RE: Zimmerman Property
3442 Adeline Street
Oakland, California
Alameda County Fuel Leak Case No. R00002936
Clearwater Group Project # AB013G

Re: **Work Plan Addendum for Additional Subsurface Investigation and Contaminant Migration Control**
Zimmerman Property
3442 Adeline Street
Oakland, California
Alameda County Fuel Leak Case No. RO0002936
Clearwater Group Project Number AB013G

Purpose of Work Plan Addendum for Additional Subsurface Investigation and Contaminant Migration Control

Proposed Groundwater Extraction Trench and Soil Boring Locations
 3442 Adeline Street / 3433 Chestnut Street
 Oakland CA.

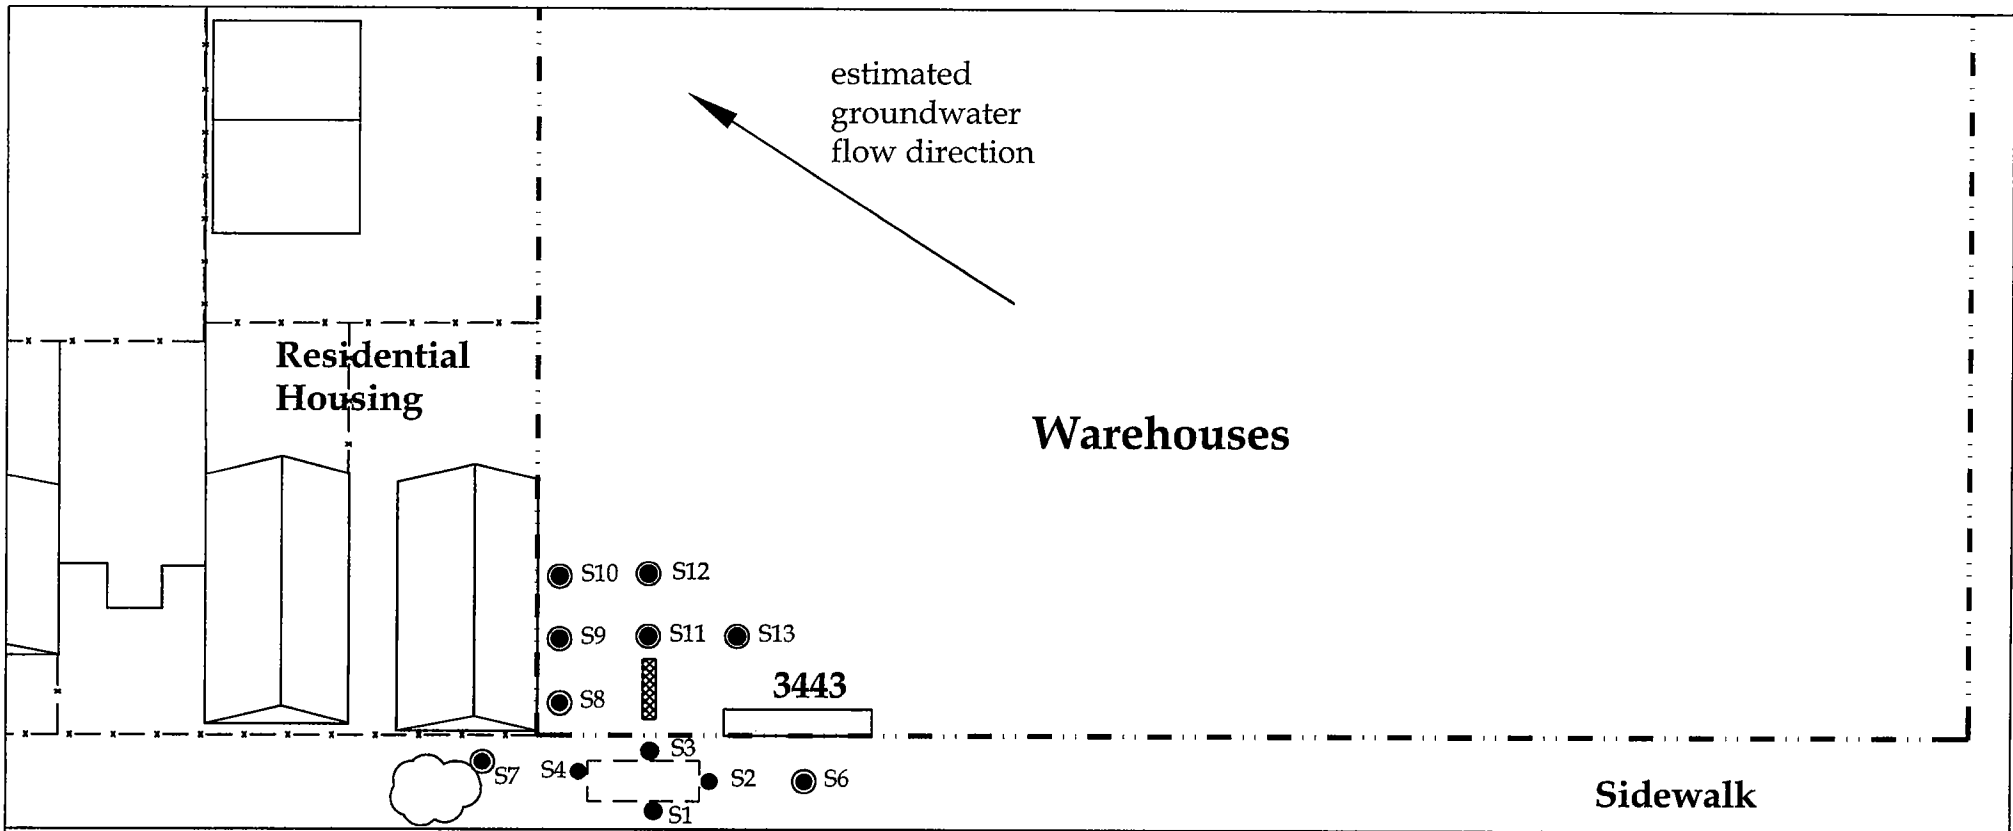
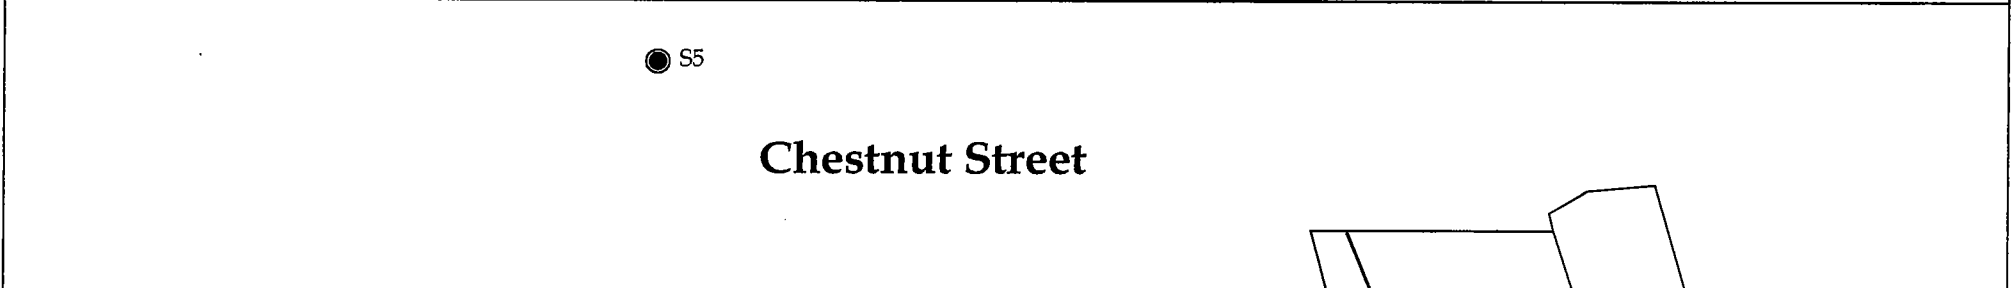
Mr. Plunkett also requested that the number of soil borings be reduced from the 12 soil borings previously proposed in the *Work Plan for Additional Subsurface Investigation and Contaminant Migration Control* to 9 soil borings. It is assumed that the 9 soil borings will provide the data necessary to define the orientation of the dissolved plume, the horizontal extent of the hydrocarbon plume and the subsurface characterization needed to strategically place a groundwater extraction trench to implement petroleum hydrocarbon migration control. To minimize confusion in the future with regard to the number of soil borings completed at the site, the proposed locations of the soil borings were renumbered on an updated version of **Figure 3**.

the proposed soil boring locations, ACEH has determined the soil borings in their current configuration are unusually close spacing; in particular, the outlying soil borings S12, S14 and S16 may not be useful for dissolved phase plume characterization. While these soil-boring locations may provide additional data, more importantly, the proposed soil borings S12, S14 through S16 are unlikely to define the orientation of the dissolved plume. Furthermore, if soil and groundwater contamination is detected in soil borings S8, S10 or S11 an additional offsite investigation will be required. In addition, soil borings S7 and S9 are not necessary at this time. Therefore, ACEH has determined six soil borings are sufficient during this phase of investigation. Please present the results of the Soil and Groundwater Investigation Work Plan (SWI) requested below

Clearwater proposed in the *Work Plan for Additional Subsurface Investigation and Contaminant Migration Control* dated March 28, 2007, to complete the installation of 12 soil borings, S5 through S16, to a depth of approximately 16 feet below ground surface (bgs) using direct push technology to define the vertical and horizontal impact of the hydrocarbon plume sourcing from the former UST at the property. **Figure 2c** and **2d** show levels of contamination in soil and groundwater at the property. The proposed soil boring depth was based on observations made during the June 23, 2006, subsurface investigation event at which it appeared that the sorbed phase contamination did not extend below 14 feet bgs.

Mr. Plunkett requested that the soil borings be continuously cored to 20 feet bgs. Soil samples are to be collected every 4 feet for submittal to the project laboratory for analysis of total petroleum hydrocarbons as diesel (TPH-d) by EPA Method 8015 and total petroleum hydrocarbons as gasoline (TPH-g), benzene, toluene, ethylbenzene, and xylenes (BTEX) tertiary amyl methyl ether (TAME), methyl tertiary butyl ether (MTBE), ethyl tertiary butyl ether (ETBE), diisopropyl ether (DIPE), tertiary butyl alcohol (TBA), and lead scavengers 1,2-dichloroethane (1,2-DCA) and 1,2-dibromoethane (EDB) using EPA Method 8260B. The soil samples collected at the termination of the soil boring, 20 feet bgs, will be analyzed if the laboratory reported detectable concentrations of the constituents of concern in the soil samples collected at the 16-foot interval bgs.

Proposed Soil Vapor Sample Locations

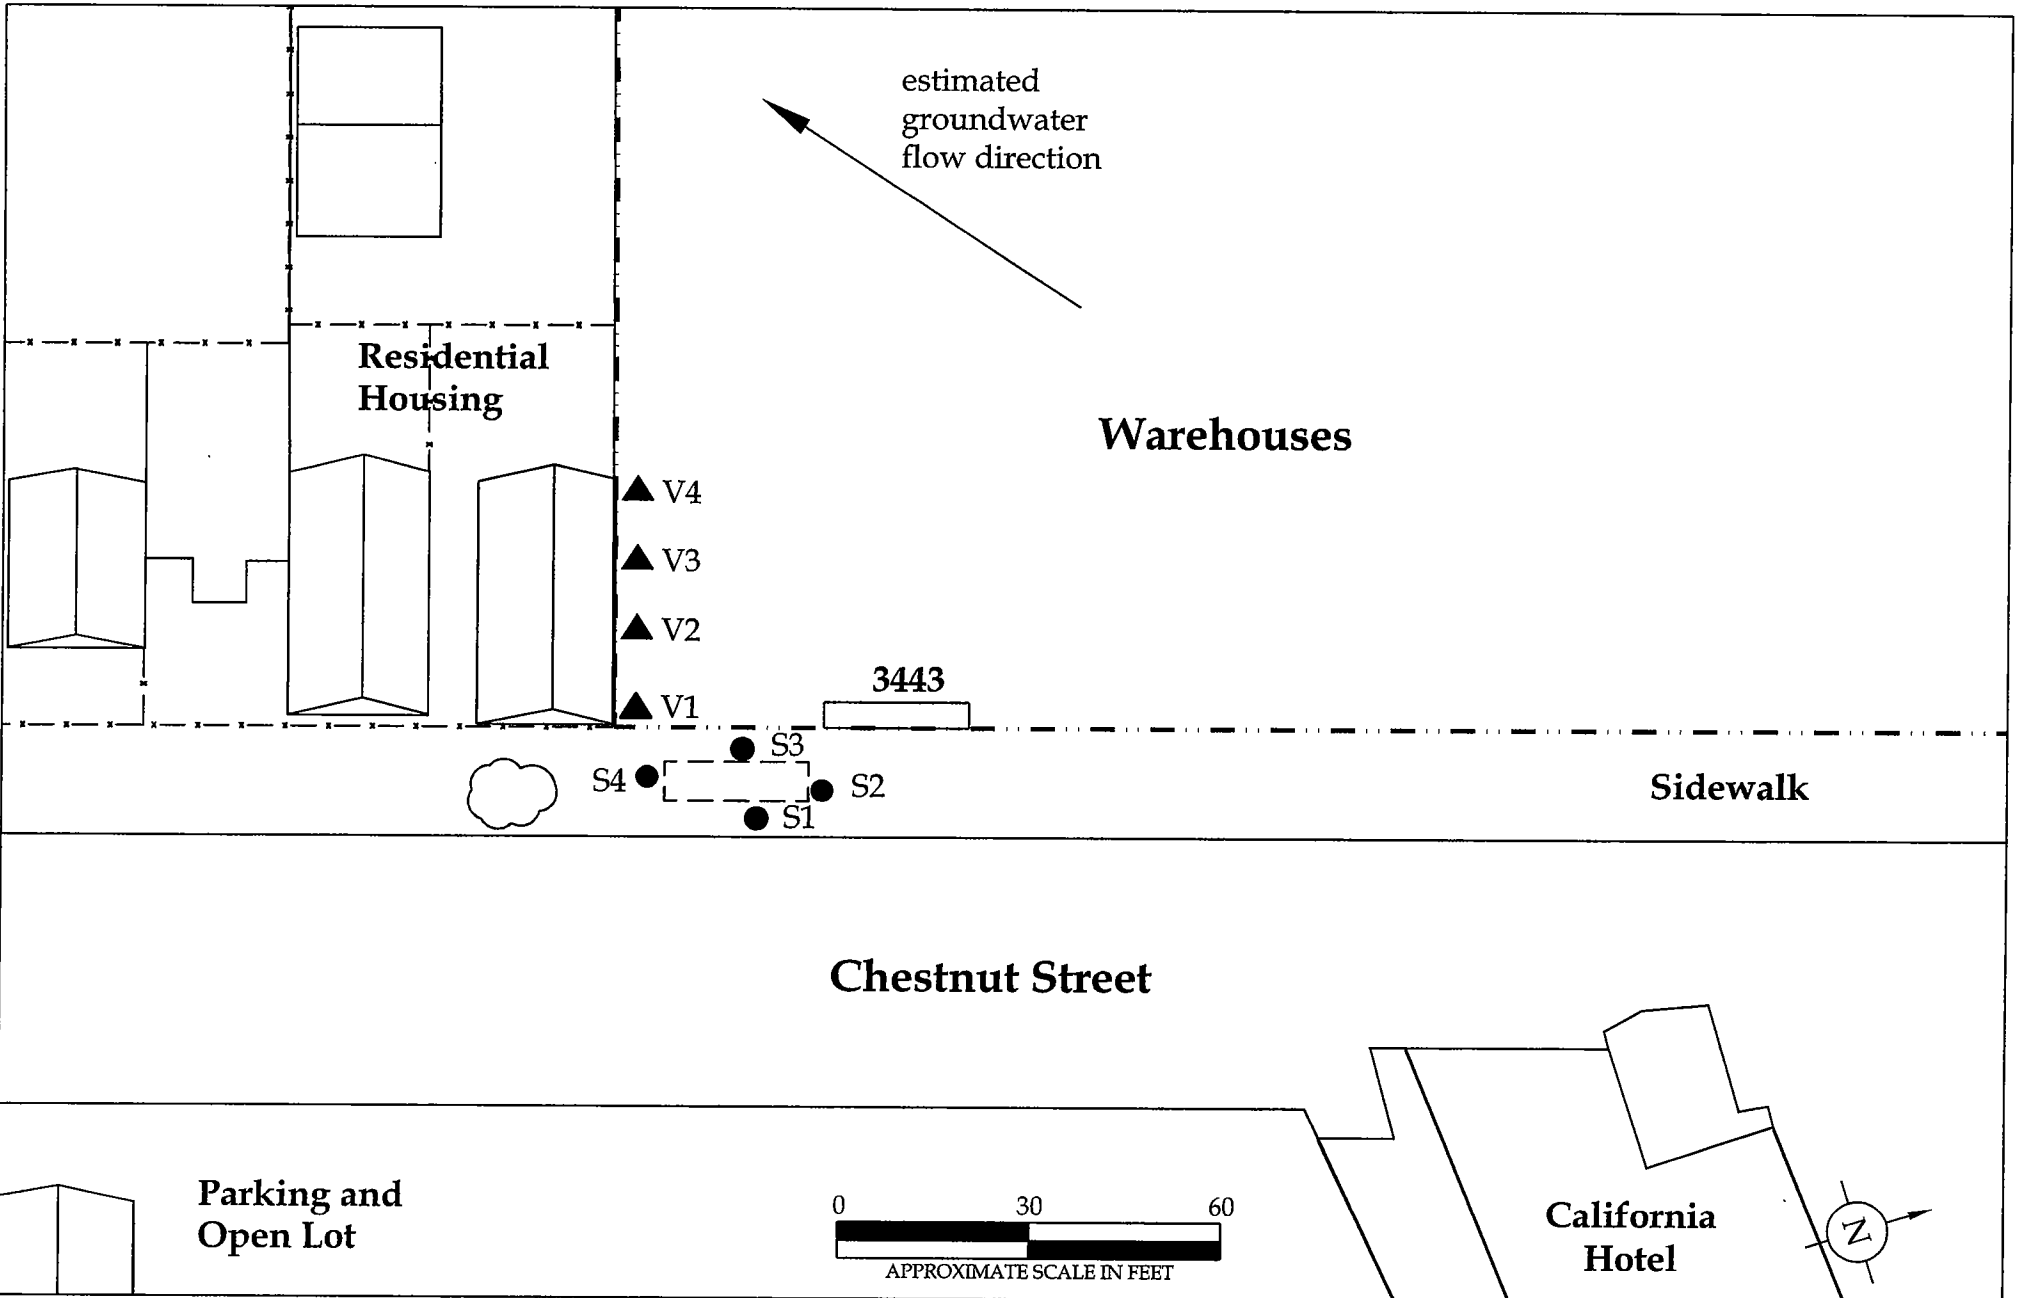
In both the April 23, 2007, letter from ACEH and during the May 16, 2007, project meeting, the possibility of soil vapor intrusion into nearby residences was discussed. A review of the groundwater elevation data for the Thrifty Service Station located at 3400 San Pablo Avenue in Oakland, California, (one block east of the subject property) indicates that the observed groundwater flow direction in the area of the project site (on January 17, 2007) is to the southwest (**Attachment C**). Because the closest occupied residence is located directly southwest of the former UST excavation area, Clearwater recommends that at least 4 soil vapor samples be collected on the subject property (in the warehouse) along the southwest wall of the warehouse which is immediately adjacent to the residence (**Figure 4**) to evaluate possible vapor intrusion pathways of the contaminant, benzene.

3. **Vapor Intrusion and Soil Gas Investigation.** Review of groundwater elevation data at nearby UST sites confirms the current groundwater flow direction for your site is toward the southwest, directly in line with nearby residences. In addition, analytical data collected during the preliminary site assessment indicate residual petroleum hydrocarbon contamination in soil may be continuing to add mass to the dissolved petroleum hydrocarbon plume. Of particular concern is the presence of benzene in groundwater at concentrations of up to 7,000 ppb, approximately 25 feet from the closest residence. ACEH requires that the vapor intrusion pathway must be evaluated in conjunction with the proposed soil and groundwater investigation. Please prepare a revised Work Plan and discuss your proposal to perform a soil vapor survey, and thus evaluate the vapor intrusion pathway. The revised work plan is to include soil vapor sampling locations and recommendations for soil vapor sample analysis.

Clearwater recommends that the soil vapor samples, V1 through V5, be collected using Direct Push Technology with a Macro-Core® Soil Sampler according to Clearwater's *Soil Vapor Sampling Procedures Where Total Petroleum Hydrocarbons as Diesel is a Suspected Constituent of Concern* (**Attachment B**). Because of the poor recovery rates of TPH-d using EPA Method TO-15 Clearwater recommends that the soil vapor samples be collected at approximately 5 feet bgs and analyzed using EPA Method TO-17 for concentrations of TPH-d, TPH-g, BTEX, MTBE, TBA, TAME, ETBE, DIPE, 1,2-DCA and EDB by Air Toxics, LTD. of Folsom, California. Soil vapor samples will be collected prior to the completion of soil borings S5 through S13. If required, confirmation samples may be collected using Summa canisters and analyzed EPA Method TO-15.
